**Cockle Bay Park Landbridge over the
Western Distributor**

Landbridge Design Principles

21 September 2017

Revision: 2

Temporary Wheat Rd Diversion

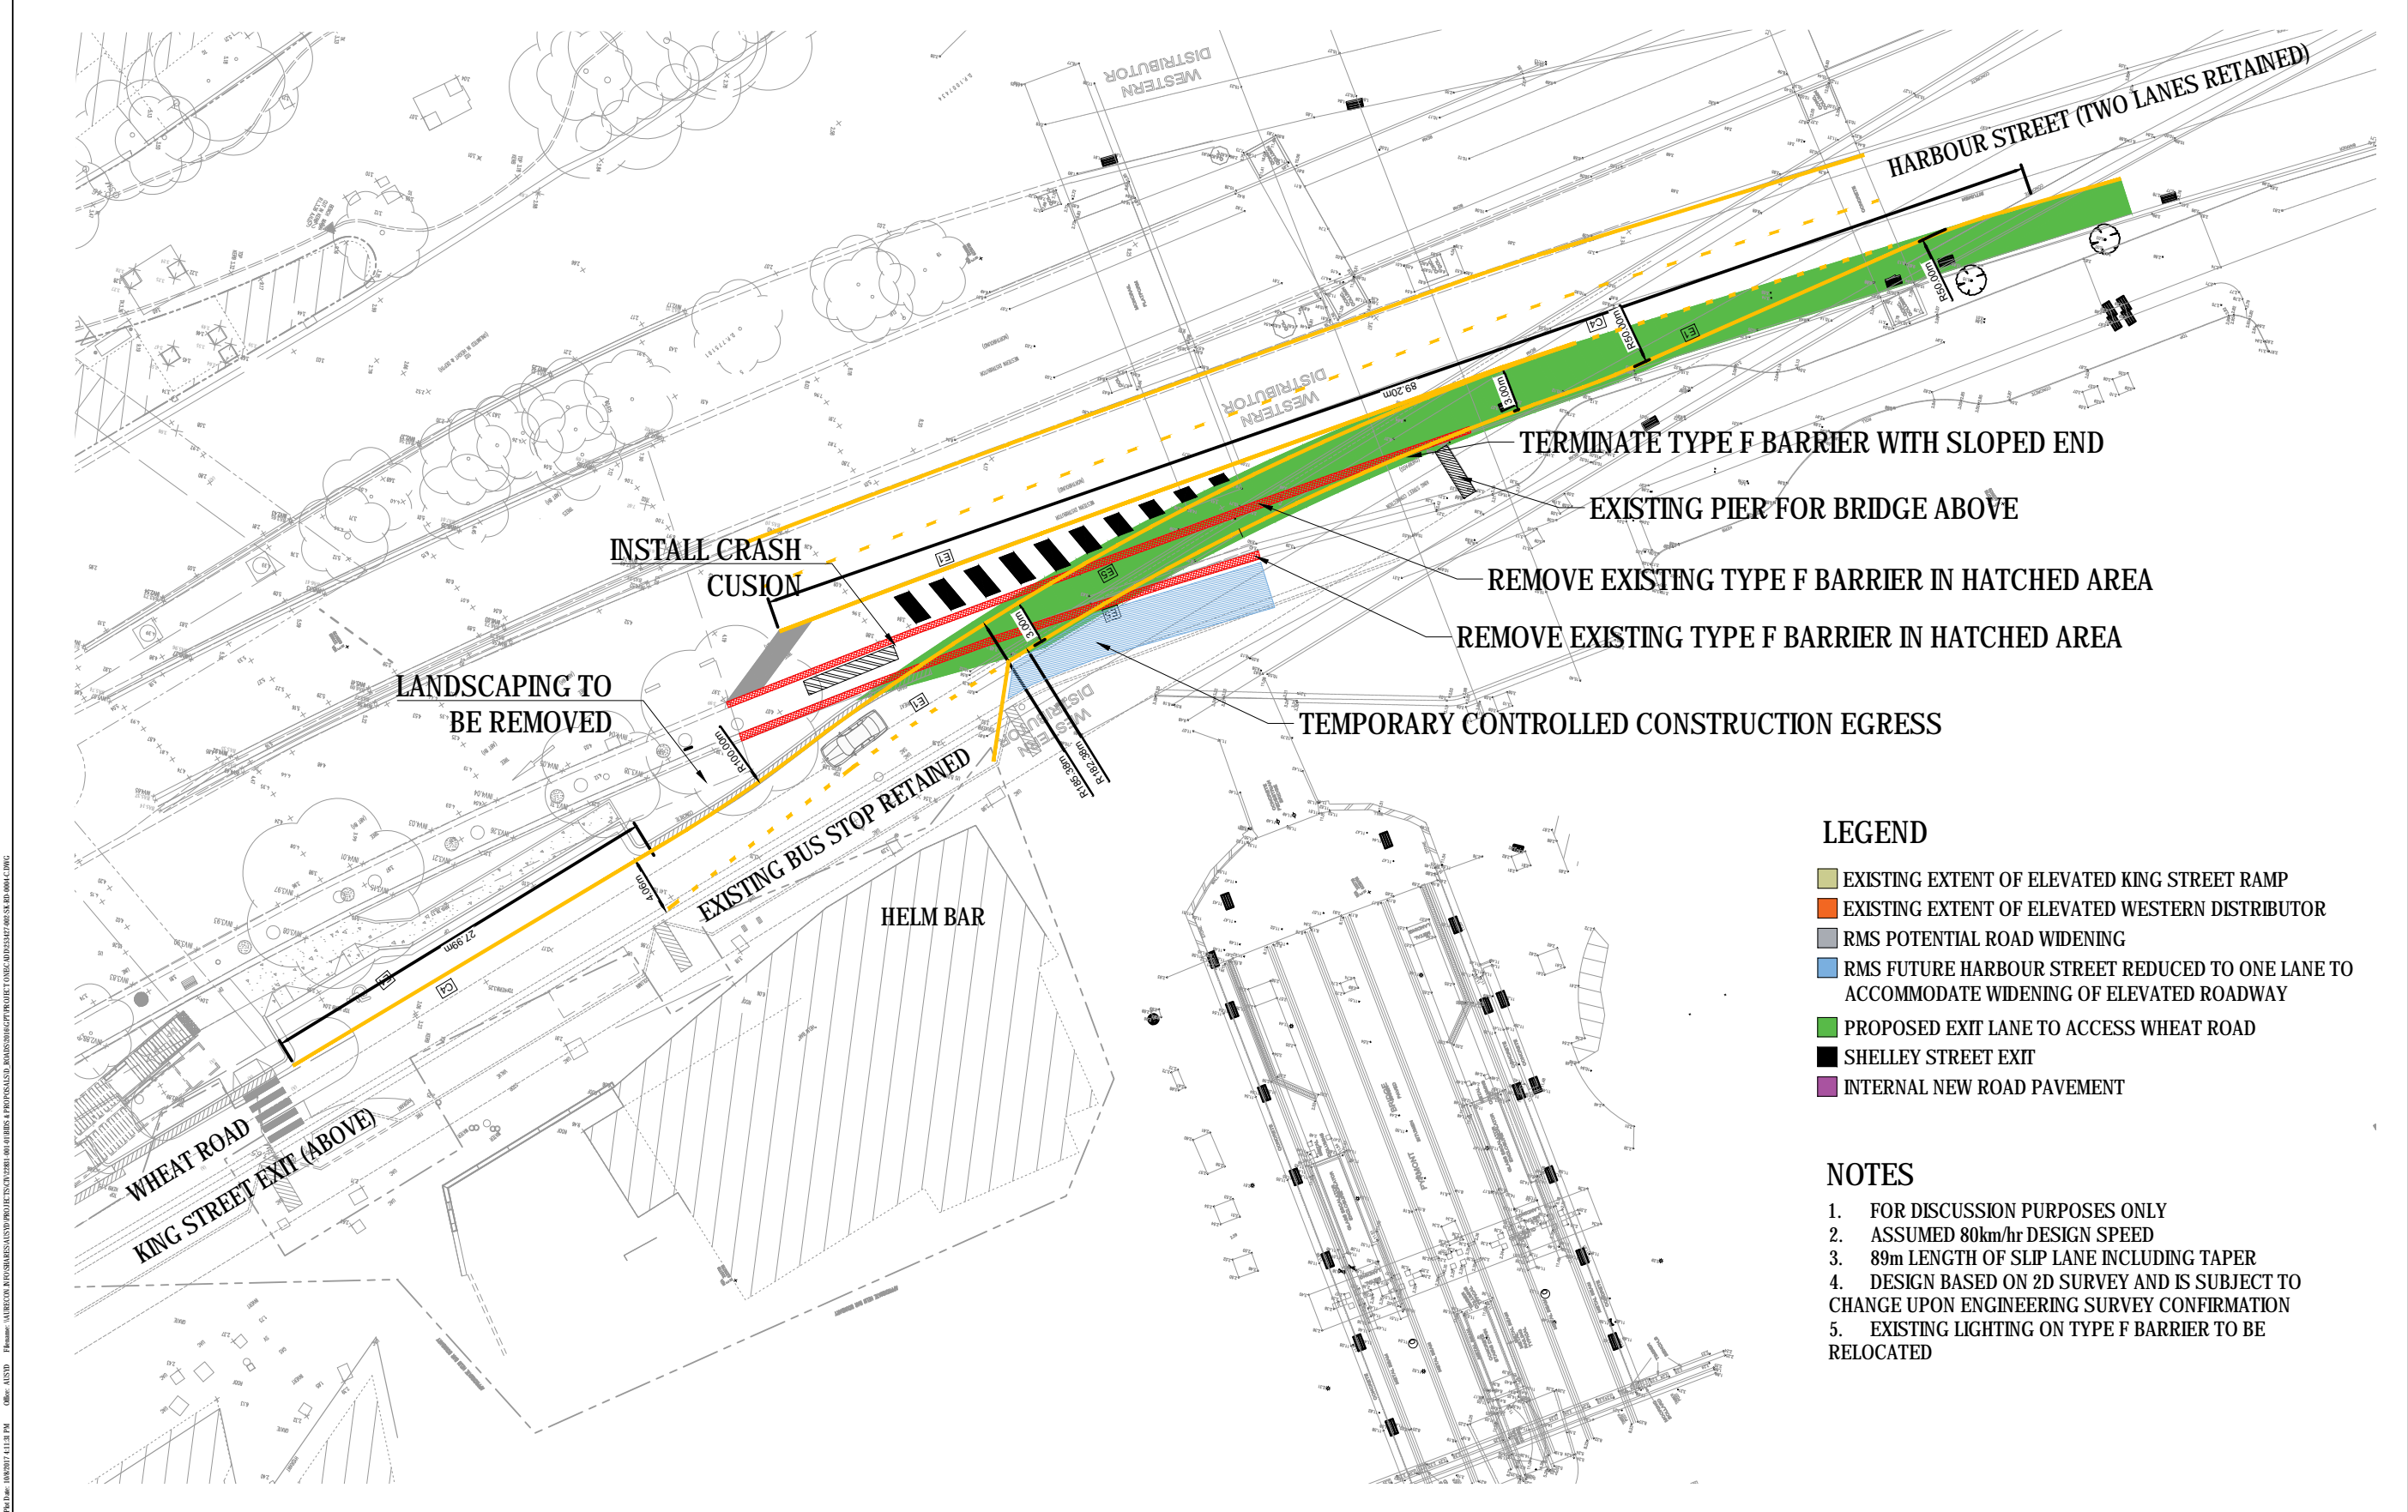
- f) **Wheat Road** – the proponent will need to provide further details of the arrangements to be made around the Site, particularly around Wheat Road, to enable safe and efficient vehicular access to the Project without unreasonably interfering with existing traffic flows. Roads and Maritime notes that there is currently an approved development for the IMAX Theatre which contemplates potential changes to these roads. Any proposed changes in this development application need to be consistent with any changes approved as part of the IMAX Theatre redevelopment (SSD 7388). The proponent will need to ensure that access, including emergency access, is maintained at all times to the Cross City Tunnel assets including in and around the ventilation stack, to the satisfaction of Roads and Maritime and the Cross City Tunnel operators. In this regard, the Project contemplates the modification of the Harbour Street/Wheat Road and Blackwattle Place intersection to allow left and right turn movements on to Harbour Street, however, the modifications contemplated by the Project would unreasonably compromise through traffic movements in this area and the traffic volumes contemplated by the Project do not warrant traffic control lights. The proposed intersection arrangement should be investigated from a road safety perspective and details of how taxi, pedestrian and vehicle movements will be affected under the proposed modifications and how the changes should be maintained should be considered.

Provision of a slip lane for Wheat Road exit (refer to Appendix D and J)

- Removal of Wheat Road and back of house conflicts associated with the development;
- Improved alternate access to Shelly Street such that the Harbour Street ramp metering can be optimised to meter traffic destined for the Harbour Bridge without delaying traffic destined for Shelly Street;
- Speed reduction measures for realigned Wheat Road to be considered.
